Office Action Summary	Application No. 10/791,772	Applicant(s) NAGANAWA ET AL.	
	Examiner Zachary M. Pape	Art Unit 2835

DETAILED ACTION

Fig 1

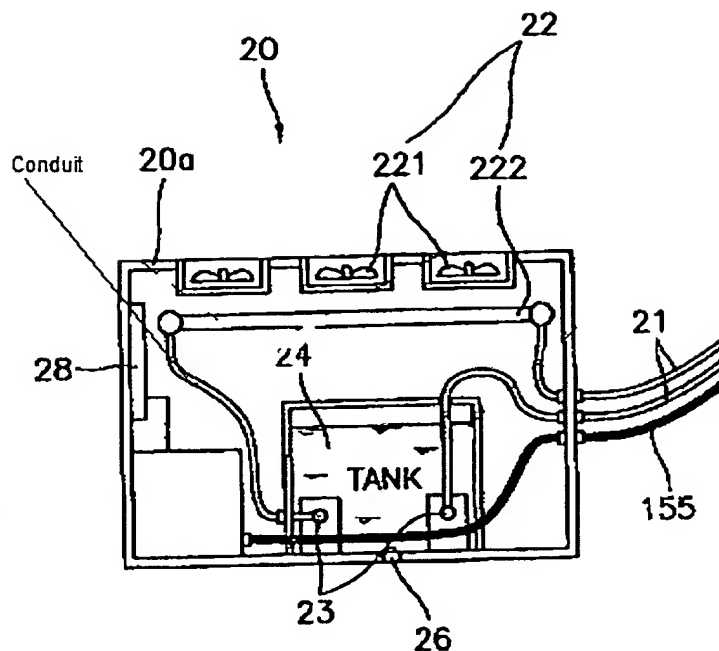
With respect to claim 2, Cheon teaches a liquid cooling system (20), comprising: a heat-receiving jacket (11) for absorbing heat generated from a semi-conductor through a liquid, which is enclosed within an inside thereof; a radiator (222) being connected with said heat-receiving jacket (11) through a flexible conduit (21) therebetween; a tank (24) being connected to said radiator through a conduit (See Present office action Fig 1 below); and a pump (23) for circulating said liquid, further comprising: a plural number of fins being attached onto a metal conduit of said radiator passing the liquid passes therethrough (See Paragraph 43, Line 3 – also see Cheon Fig 5), wherein said pump is connected to said tank (As illustrated in Cheon Fig 1), which is connected to said metal conduit, directly (Via the conduit as illustrated in the present office action Fig 1 below).

Fig 2

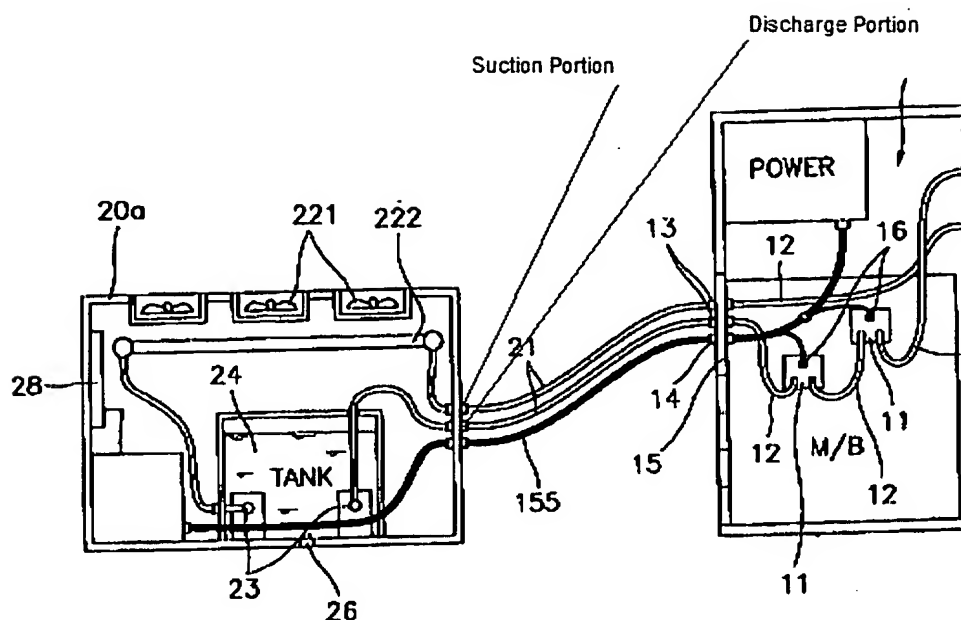
With respect to claim 8, as best can be understood by the examiner, Cheon teaches a liquid cooling system (20), comprising: a heat-receiving jacket (11) for absorbing heat generated from a semiconductor element through a liquid enclosed in an inside thereof; a radiator (222) being connected to said heat-receiving jacket through a conduit (See present office action Fig 1 above); and a pump (23) for circulating said liquid, wherein: a member building up said cooling system has a suction port (See present office action Fig 2 below) and a discharge port (See present office action Fig 2 below), and is connected by inserting those ports into port insertion openings, which are provide in said conduits (The suction port and discharge port of the "built up" cooling system are connected to the conduits via openings in the conduits such that the fluid can flow from the cooling system to the conduit and vice versa).
